File # NCE2022-000658

Relocate and Rebuild a noncomplying structure (Revised request: proposal of retaining wall to be built within 50' setback of a perennial stream corridor)

Request: Revision of previous approval to tear down rebuild FCOZ SFD (addition of Retaining wall within the 50' of high-water mark of BCC)

Figure 1. Proposed Retaining Wall (from Applicant)

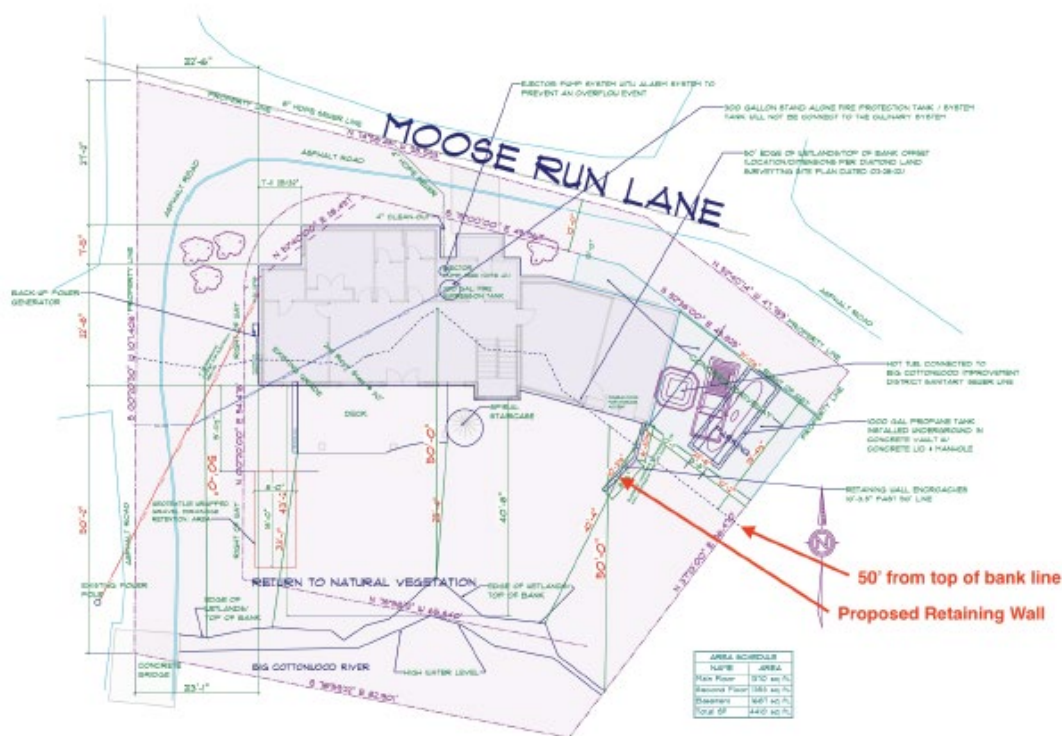
The applicant, Mike Kessler, previously received approval to relocate/rebuild a noncomplying structure on Parcel #2416356001 which is known as 10806 E Moose Run (Exhibit B). The applicant is proposing the addition of a retaining wall on the East side (running south) of the structure (exhibit), partially being proposed within the 50' high water mark of Big Cottonwood Canyon Creek. The reason for this request is that while the original architectural drawings showed a ground-level entrance to the basement of the new home, the applicant's engineer did not include the necessary retaining wall on the plans. When the updated civil drawings were submitted, staff noted that the Salt Lake City Public Utilities approval would need to be updated (per Brighton's code) and legal counsel for Brighton recommended ALJ review due to the additional encroachment in to the 50' setback.

The retaining wall as proposed does not meet the requirements of 19.72.070 due to its being over 8 feet tall (Brighton Code 19.72.070(H)(1)). It also causes the grading to be lowered more than 8' (19.72.070(c)) along the south elevation of the house and more than 8' along the east elevation of the house.

Figure 2. Setback Conforming Retaining Wall (from Applicant)

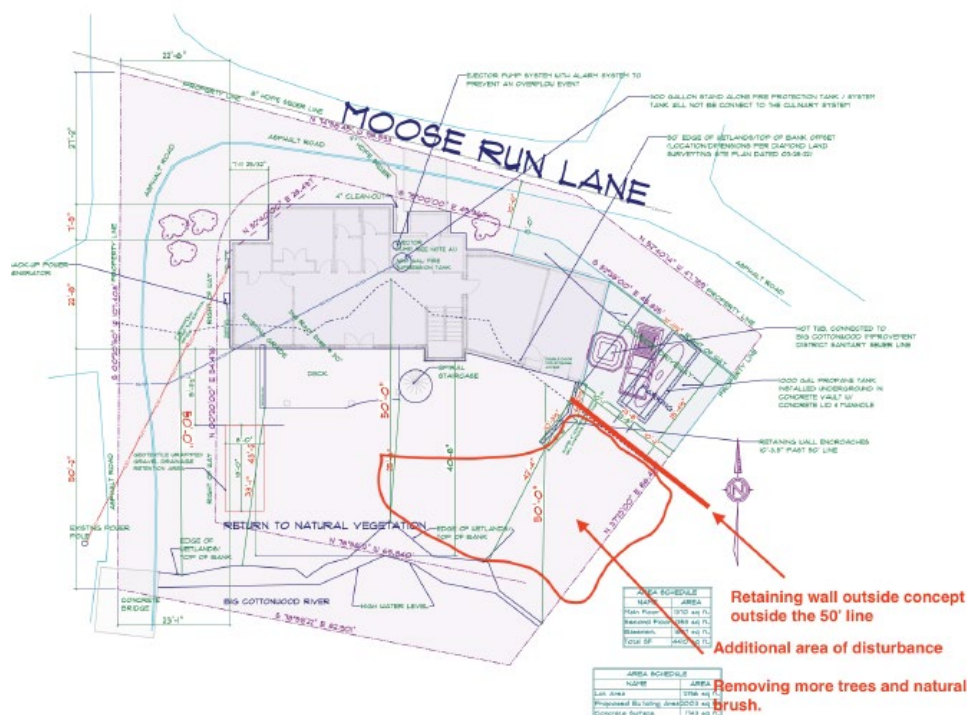
The ordinance does not prohibit grading, it encourages development that conforms to the natural contours of the land and requires that the “scarring and erosion effects of cutting, filling and grading” be minimized. Grading standards are listed in Brighton Code 19.72.070. The retaining wall could be placed in a position that complies with the 50' perennial stream setback which would retain the parking pad on the east of the house, but this requires much more cut and fill because the two accesses were permitted from the basement level, resulting in a final grade that differs from the natural contours even more than the proposed retaining wall in question (See figure 2, setback conforming retaining wall). The proposed retaining wall (see figure 1, proposed retaining wall) results in the least amount of cut and fill possible, given that the “walk out” elements are part of the approved plan. The proposed configuration therefore minimizes the effects of the cutting, filling, and grading to the extent possible.

SITE PLAN NO GRADING

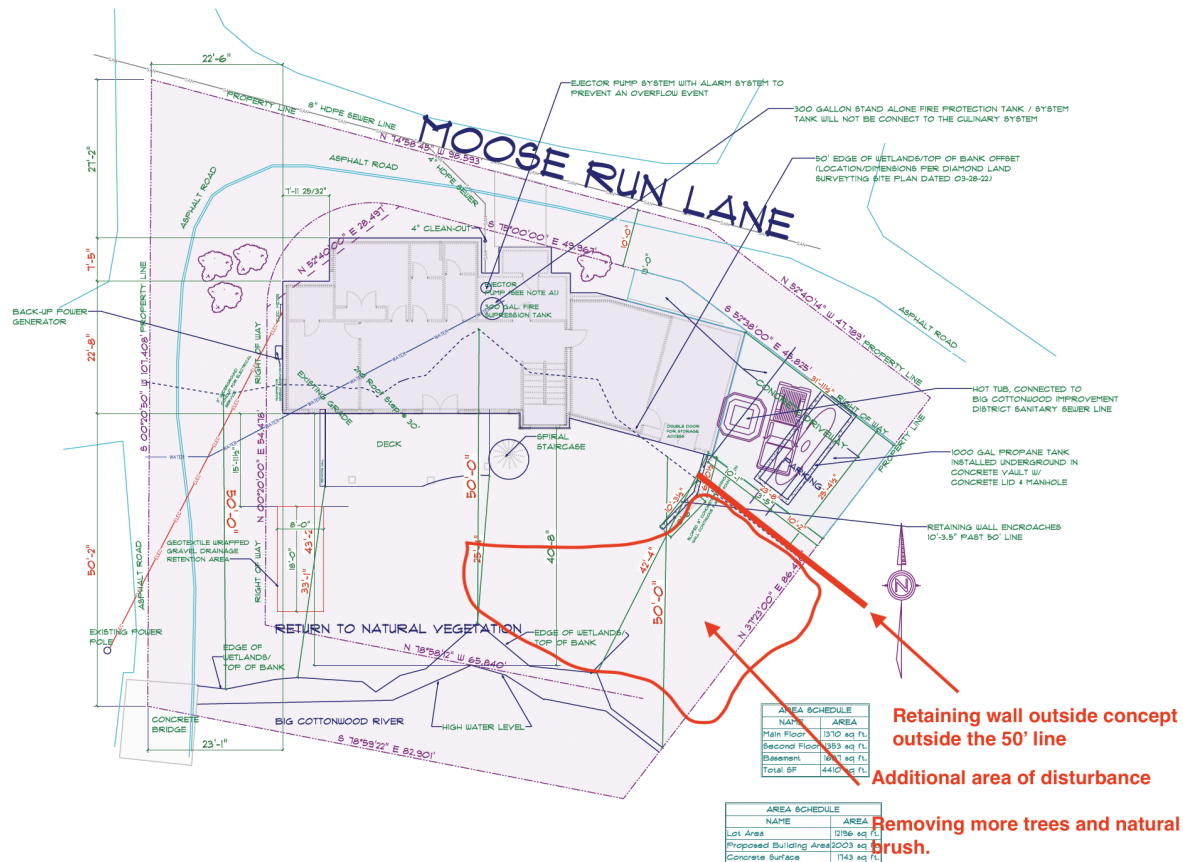
The Comment from Polly as I understand it, she requested more clarification as to why the retaining wall needs to be installed within the 50' zone shown on the Building Plat, rather than a retaining wall that would stay outside of the 50' line marked on the plat. You can see both of the options below:

The reason why the retaining wall is placed in the current location, is because this follows the natural grade of the existing ground. As requested by Salt Lake County Public Utilities and the Health Department, they wanted to have as little impact as possible on the natural and existing vegetation, thus we provided a retaining wall that follows the natural grade. This allows us to preserve as much vegetation on the lot as possible.

If we put the retaining outside of the 50' line to stay within the Ordinance, this would force us to remove more trees and natural vegetation in the area marked above. In additional, we would have to remove additional hillside and grade the ground to a slope that is safe. This is contrary to the requests made by public utilities and health departments.

Site Plan
SCALE: 1" = 20'-0"

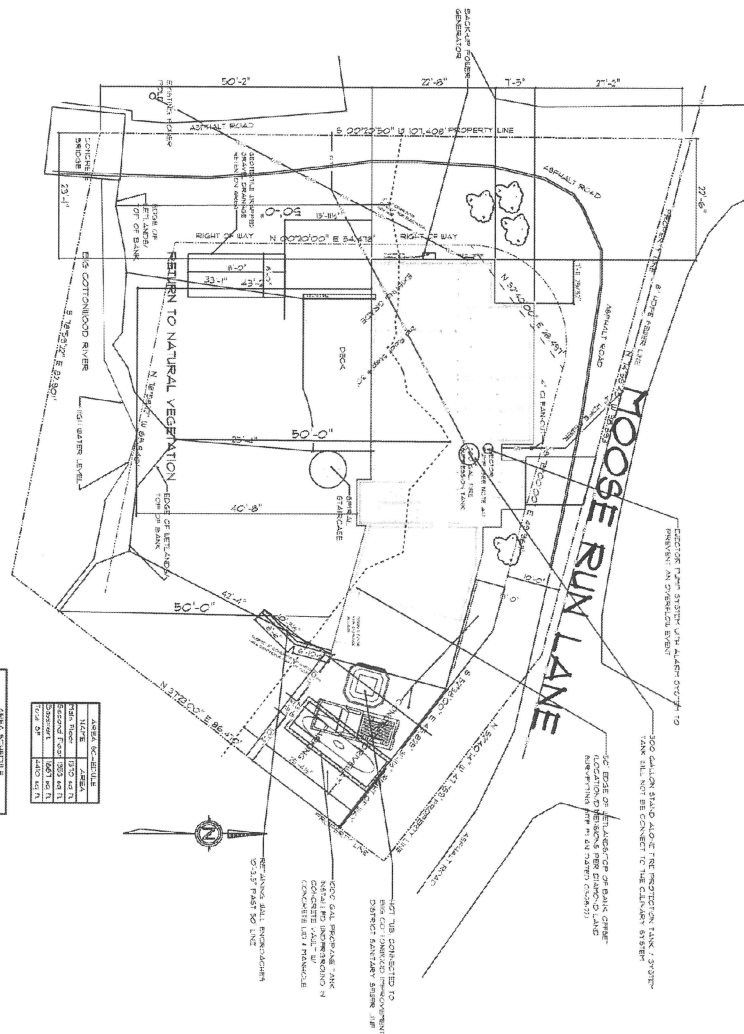
1. The Limit of Disturbance (LOD) for construction of the proposed residence shall be no closer than the one point 25-feet from the edge of wetland/top of bank and as indicated in Exhibit A. This approval is per the site plan attached herewith only. Under the current rules decks and patios are considered part of the living space structure.
